RE: Extension to the Burlington landfill site

Permit me to make comments on the technical report given
by Dillon, especially Volume 2.

Detailed technical comments or points of difference in Volume 2

SLUG TEST

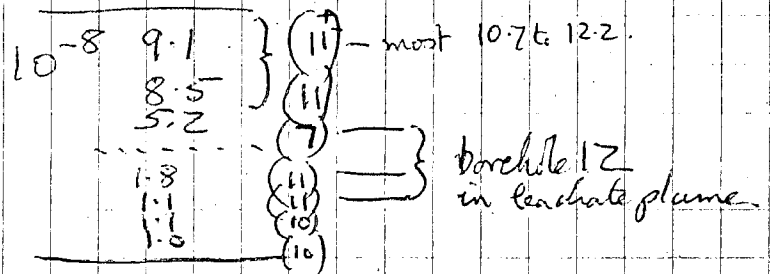
Sum of data (all) shale 24
median value = 1.22×10^{-8}
if doubled figures ignored = 9.1×10^{-8}

The conclusion to be made is that the 'assumed' value for shale is a middle value but does not correspond to anything in reality. There are not enough analyses for till which are comparable. Shale at shallow depth, to 8.5m, has permeability of 1.33×10^{-7} to 1.11×10^{-8} (no value at 9.4×10^{-9}) and it is this which will take the bulk of leachate.

K v. depth. (shale)

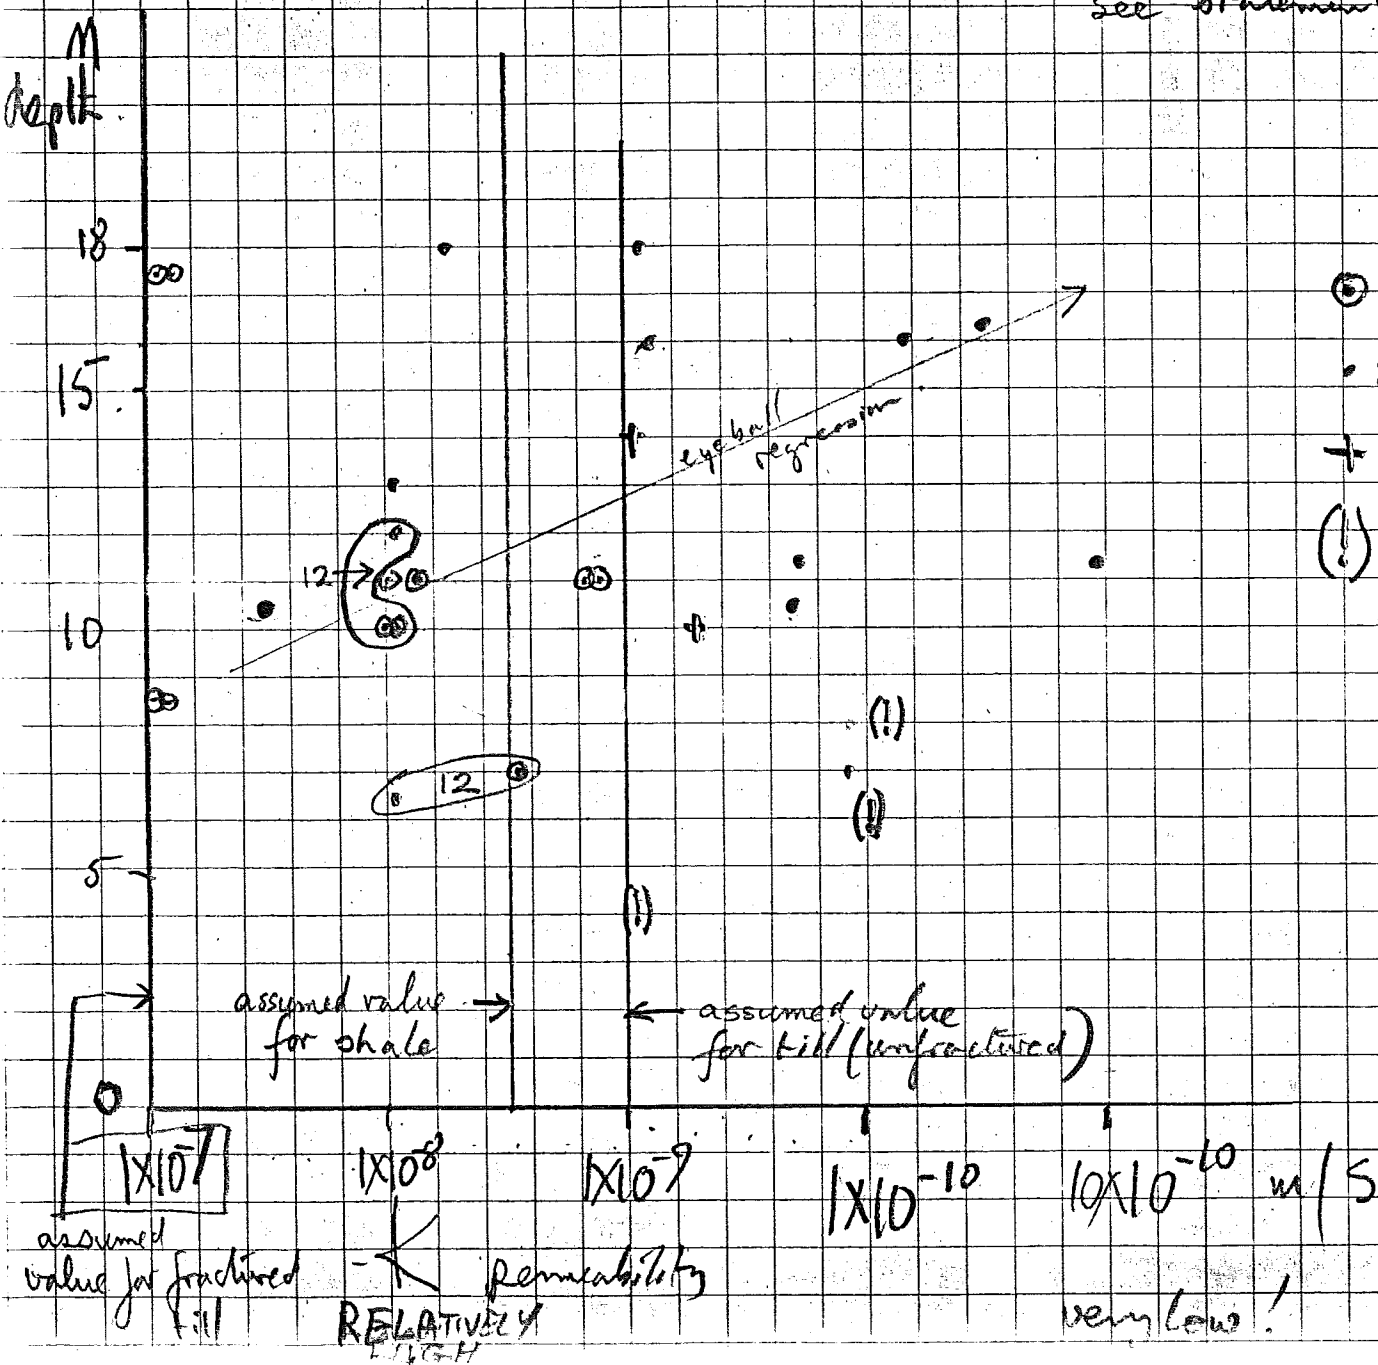
Permeability as a function of depth.

I think it quite clear that, given a few dubious peripheral values, that there is, as one would expect, a decrease of permeability with increasing depth.

②. the application of the assumed value for shale underestimates the response at site 12.

Bunting x5.

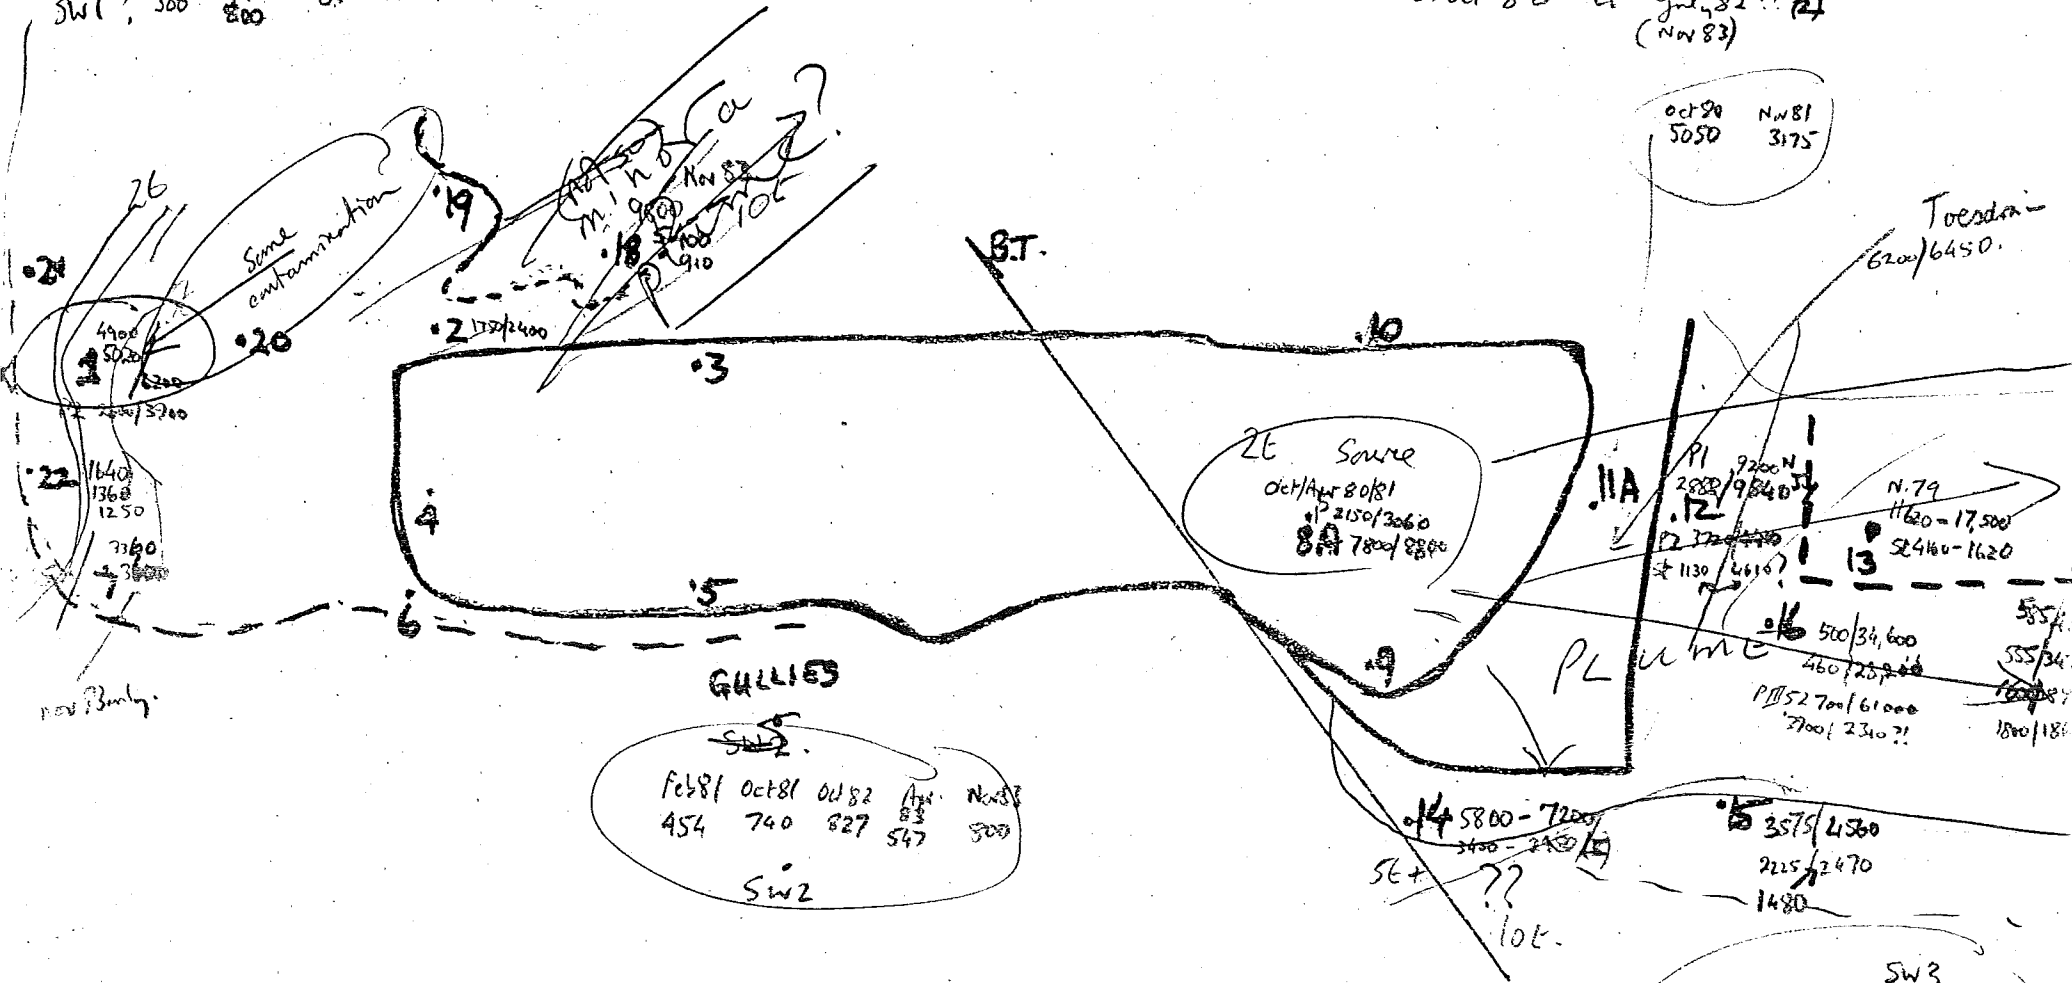
Conductivity values Initial and later

Cond change Nov 79 to Nov 83

Background C 500? C 900 to 1200 SE 10E 20E.

Bunting x6.

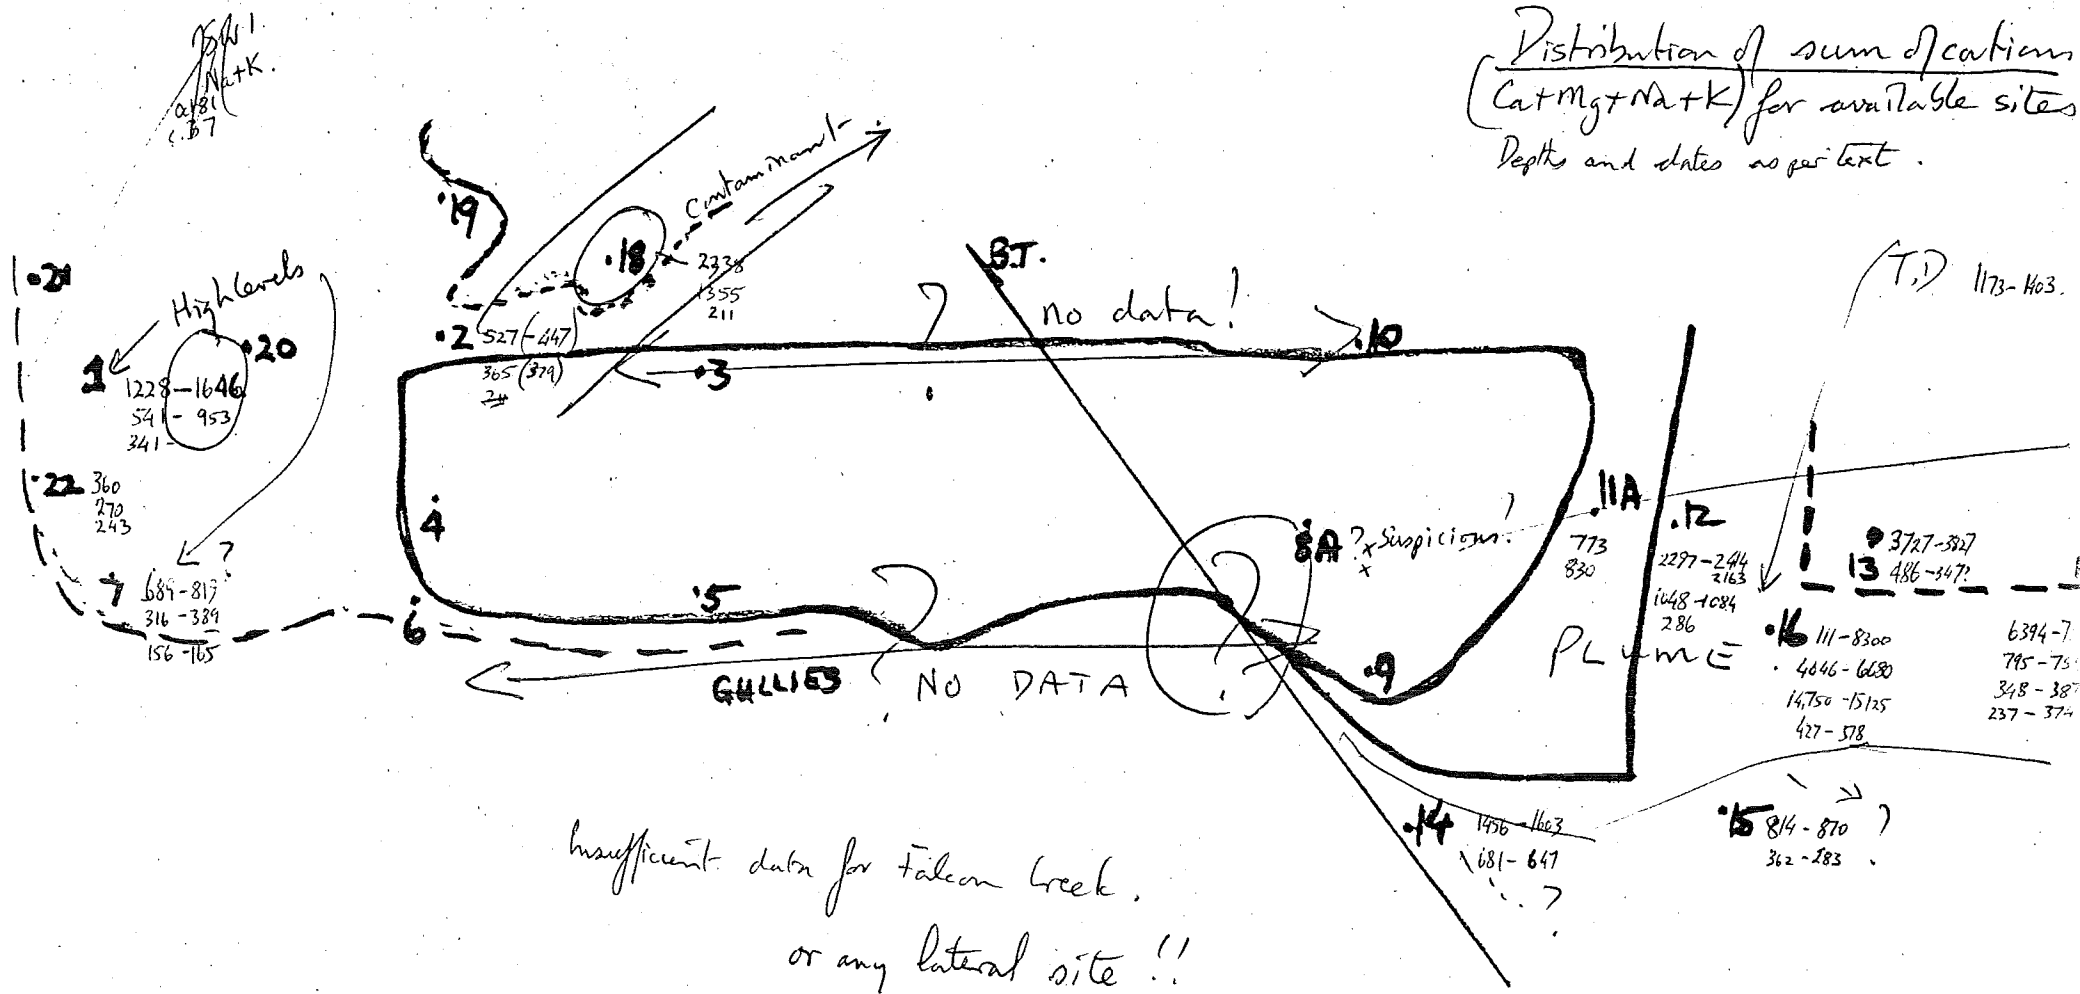
Σ cations

Distribution of sum of cations
(Cat Mg+Na+K) for available sites
Depth and dates as per text.

120-300 Background (assumed).

Bunting
x 17

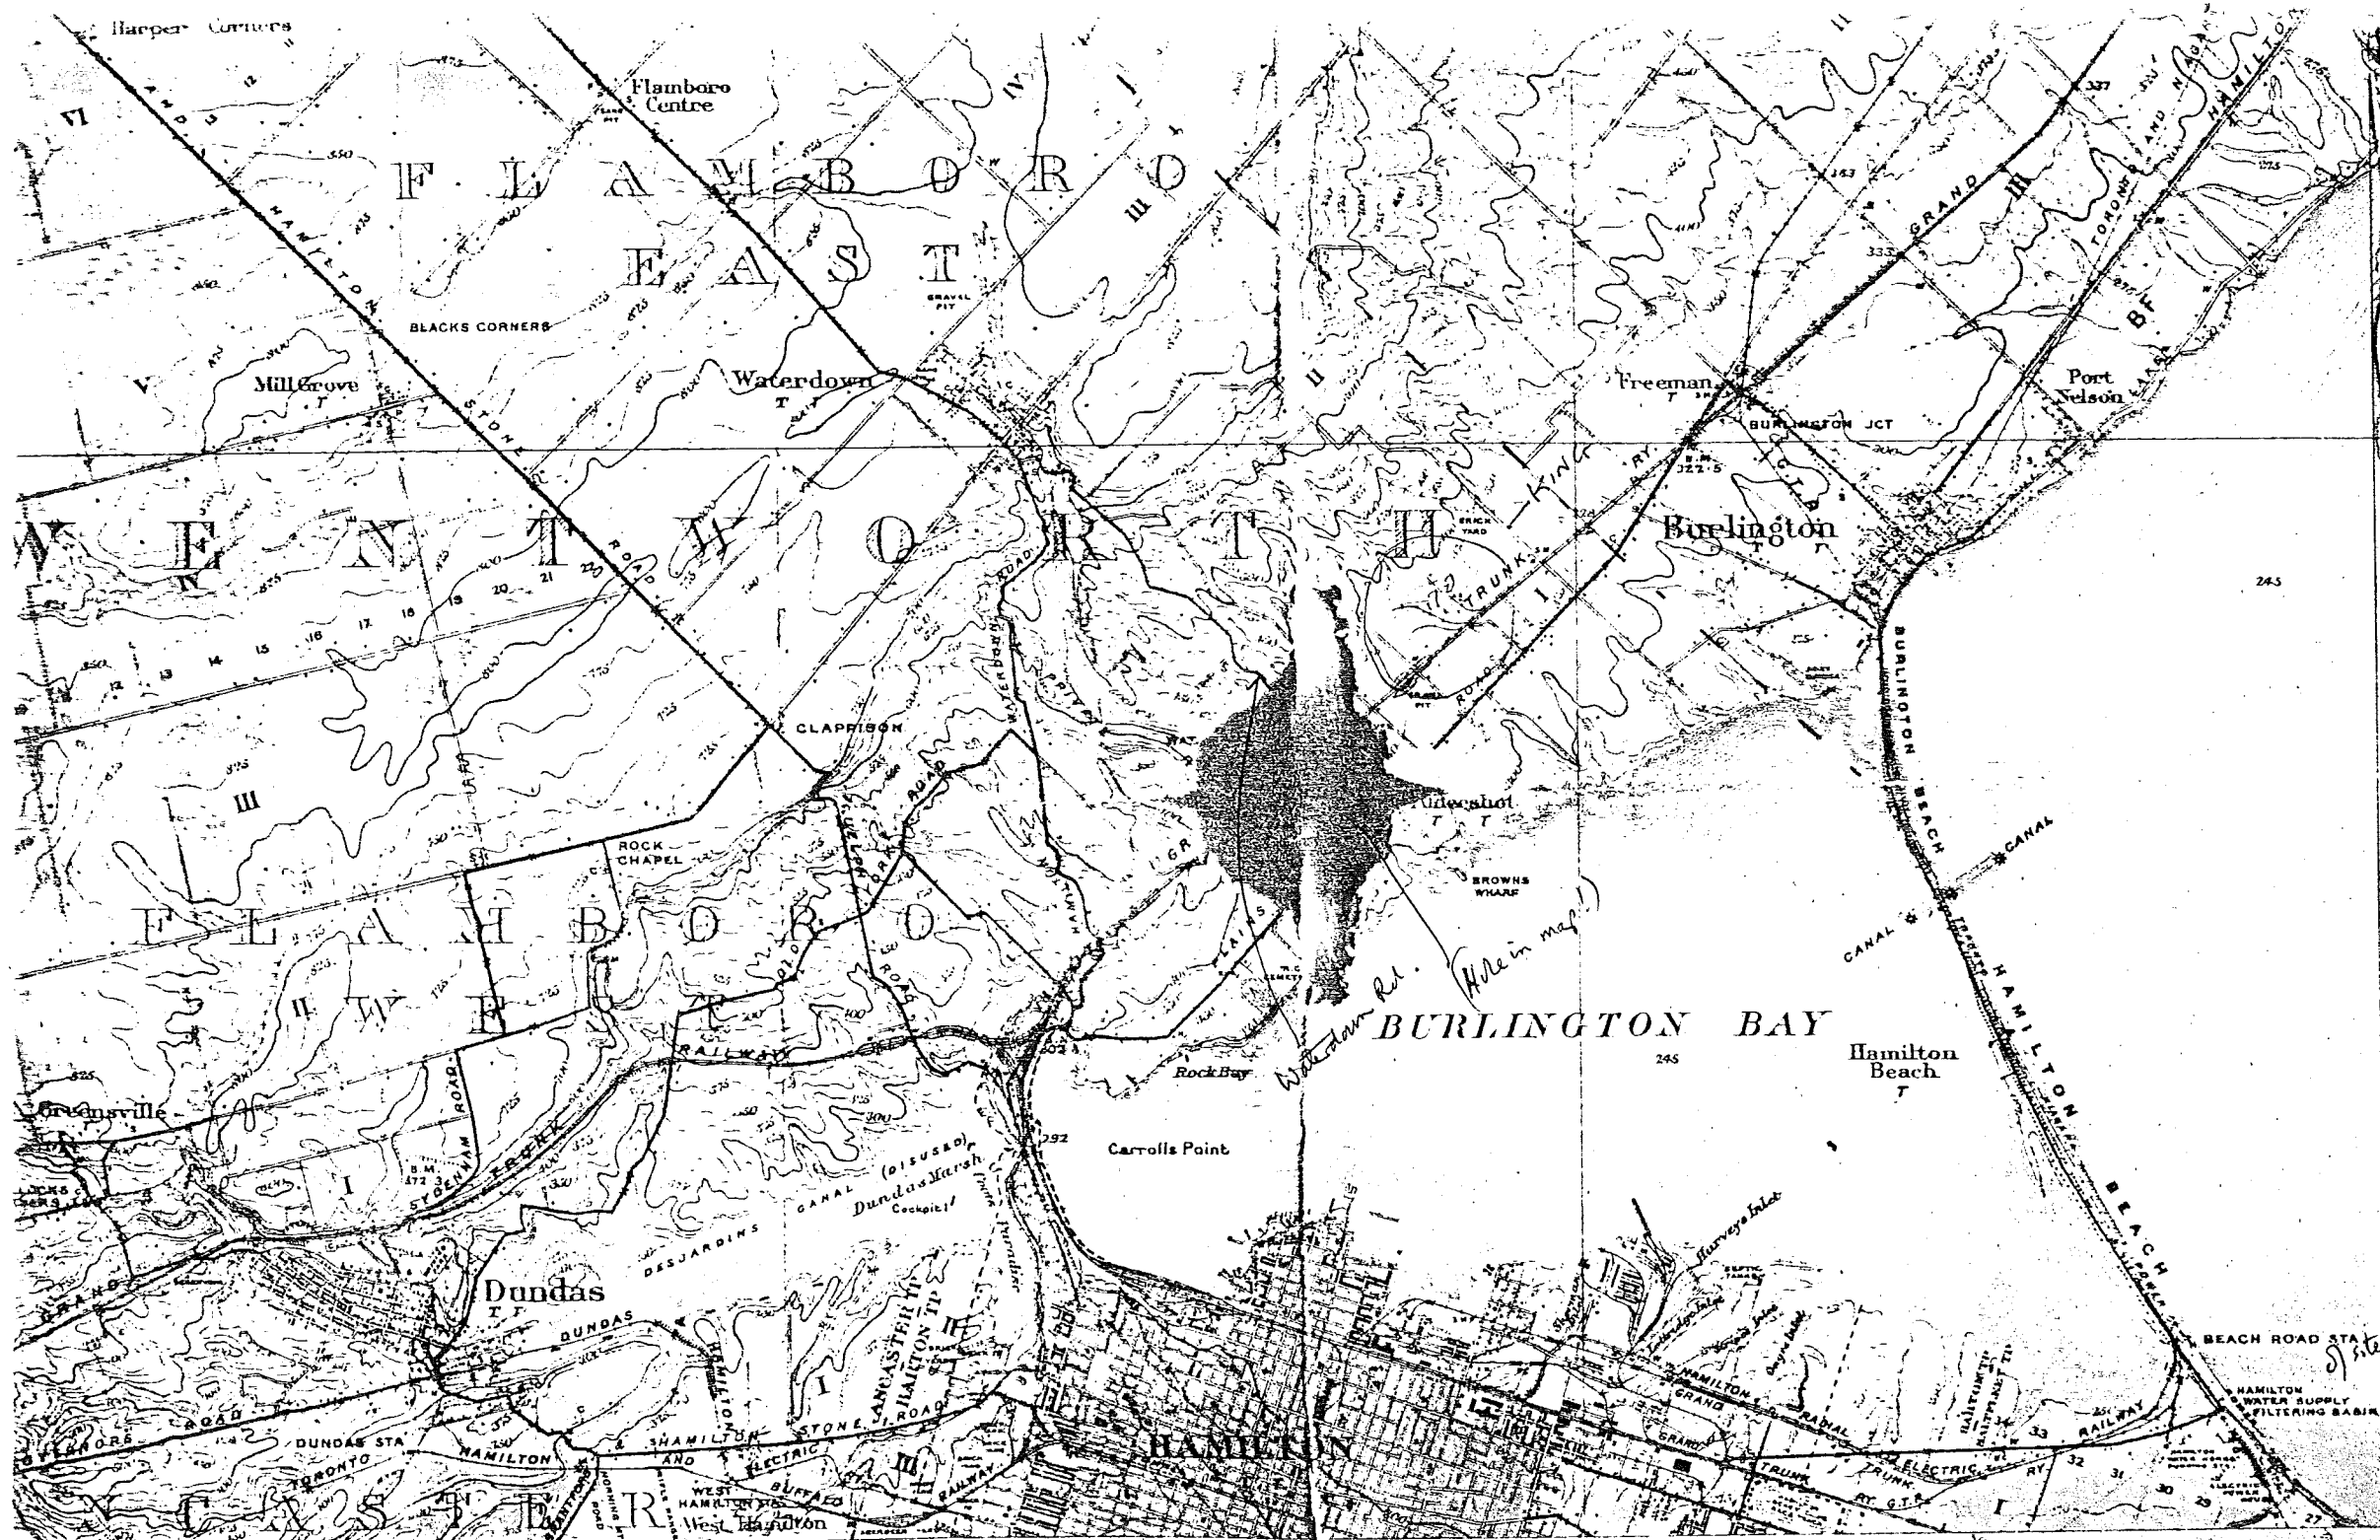
shows three
railway siding
in the general
area of the site
or westwards

Hence minor
disturbances of
the land to
the south-
east can
before the

Hence continue
of shale to S of
403 to railwa
has to be
researched

Current to
1923 (at least)
Approximately to same
403 railway siding
presumably same
day etc. excavation
now masked by 403
Muck of land between
403 & mainline is
disturbed ground
not in situ
